# **pH Monitoring Log and ECDEP Correspondence**

RE: Erie County Sewer District No. 6  
Certainteed Facility - Groundwater Discharge

Buffalo Lakeside Commerce Park,  
Site #C915185 (Krog/Certain Teed Project)  
Buffalo, Erie County

**Re: Buffalo Lakeside Commerce Park (BLCP)  
Remedial Action Work Plan (RAWPs) – Parcels 1 and 2  
Proposal for Alternative Groundwater Handling Approach**

## ALTERNATE GROUNDWATER HANDLING CONCEPT

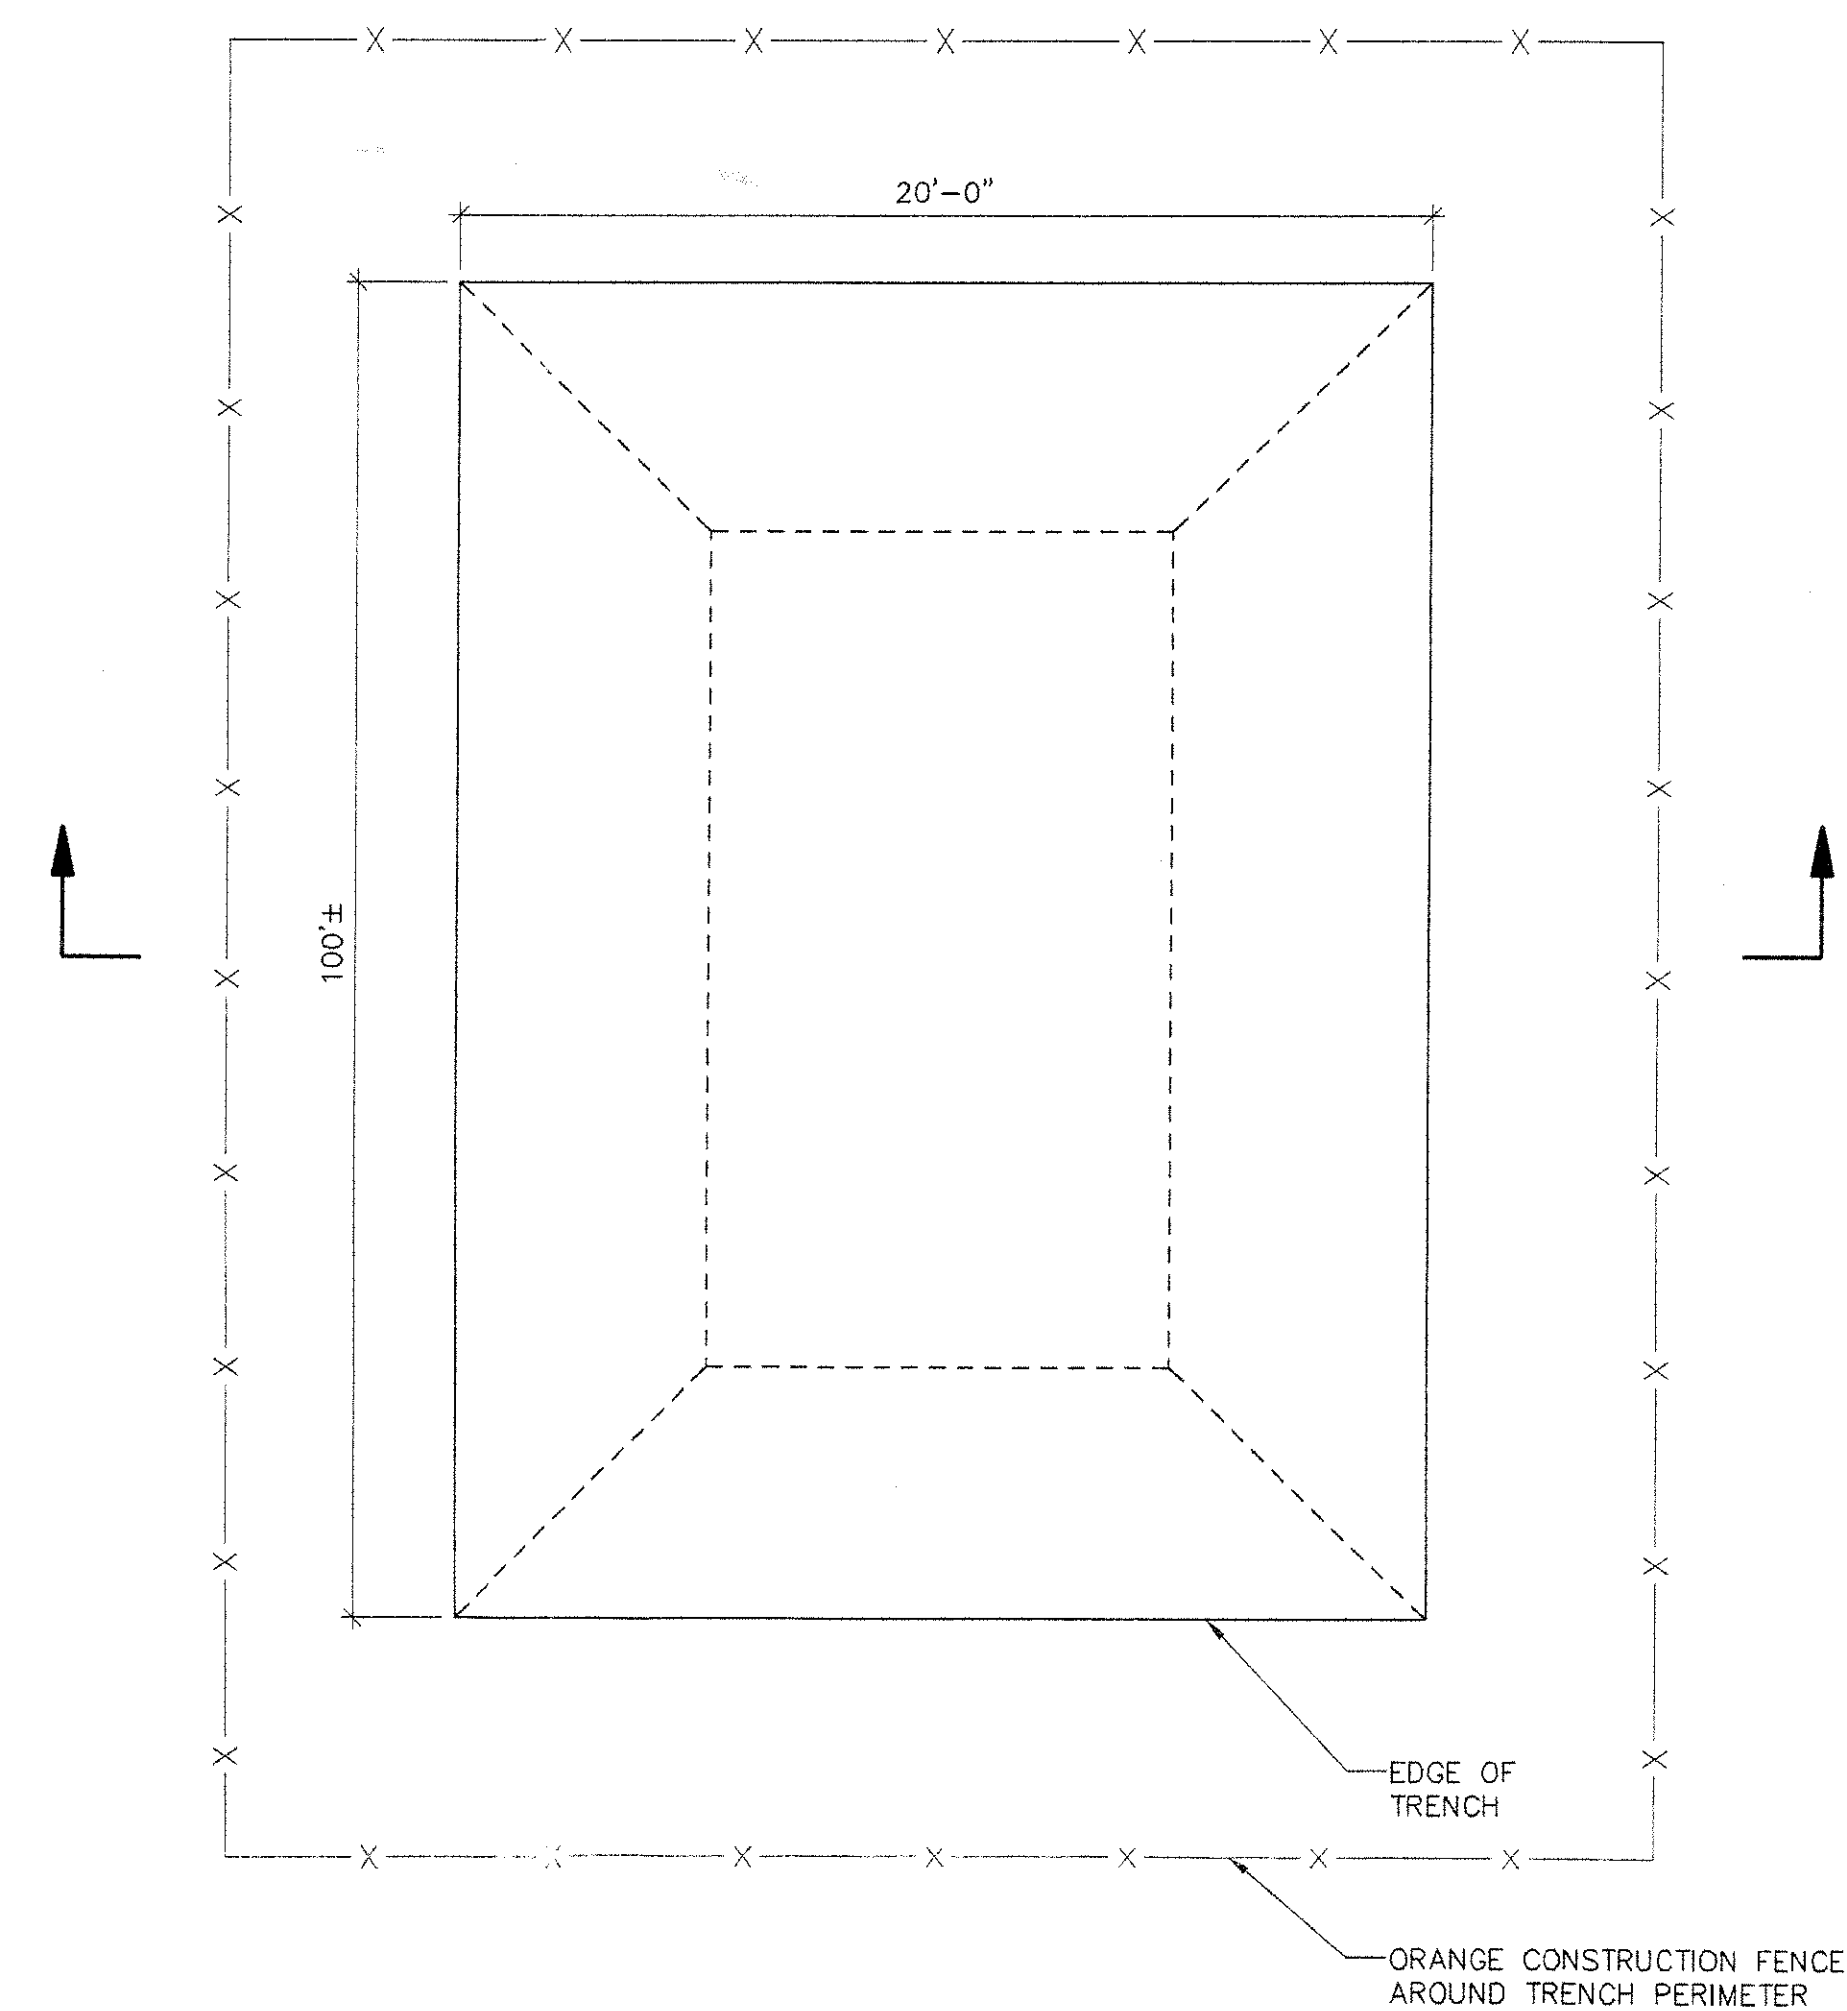
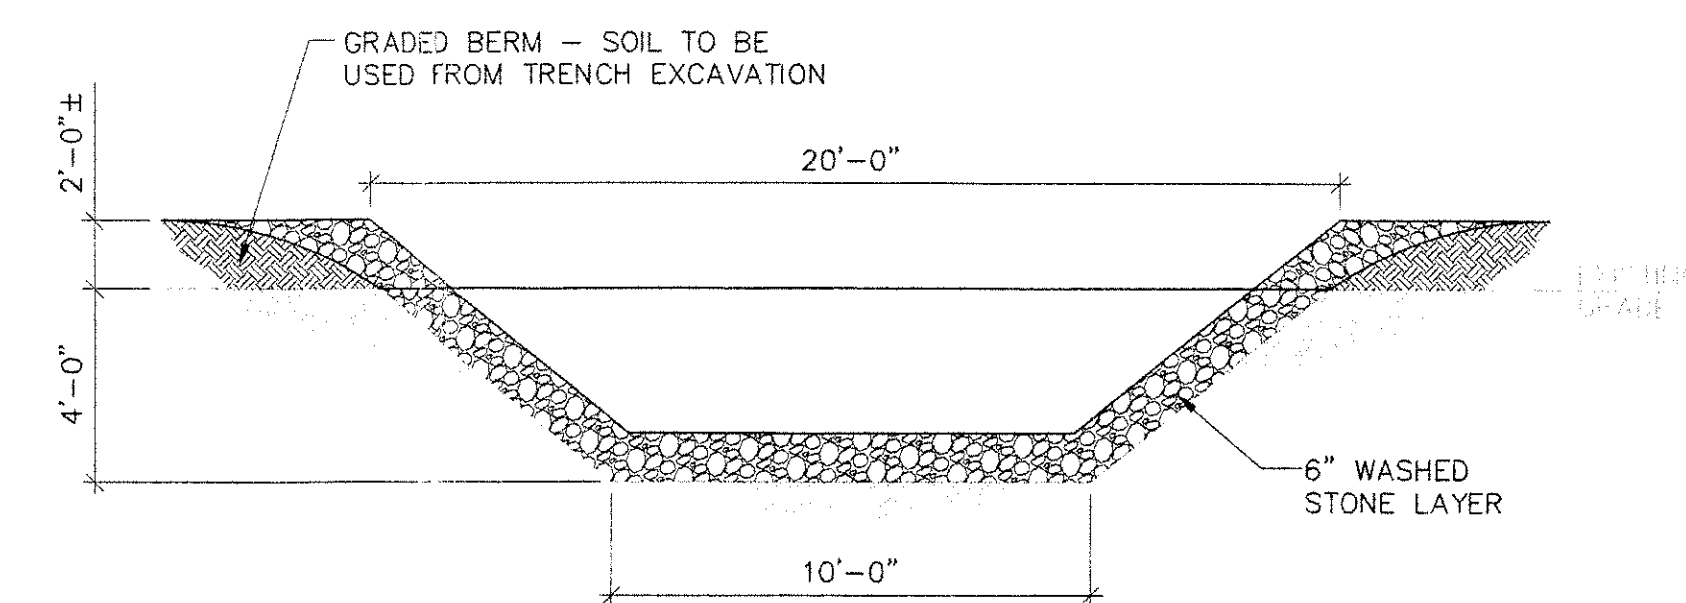
The attached drawing illustrates our proposed approach. We have designed 12 temporary groundwater infiltration trenches for use in development of Parcels 1 and 2. The planned locations and details for construction of these groundwater infiltration trenches are shown on the attached drawing. The locations were selected to facilitate access during planned construction and redevelopment activities while minimizing potential exposure hazards. The trenches will be approximately 100 feet long, 20 feet wide and four to six feet deep. The trenches will be lined

with six inches of washed stone and surrounded by orange construction safety fence to limit access.

- Each infiltration trench used shall be upgradient and no more than 500 feet from the particular work area where the groundwater is being removed. This is to minimize groundwater mounding in the vicinity of the infiltration trench and encourage the water to eventually return to the same work area from which it came.
- It is assumed that groundwater in the area generally flows to the Union Ship Canal. The drawing attached to the proposal locates one of the proposed infiltration trenches between the Phase II roadway and the canal, or downgradient of the anticipated work area. This location would be unacceptable.
- Again, the proposal is acceptable only for the Phase II roadway and Krog/Certain Teed construction projects and the NYSDEC approval extends only until April 1, 2005.
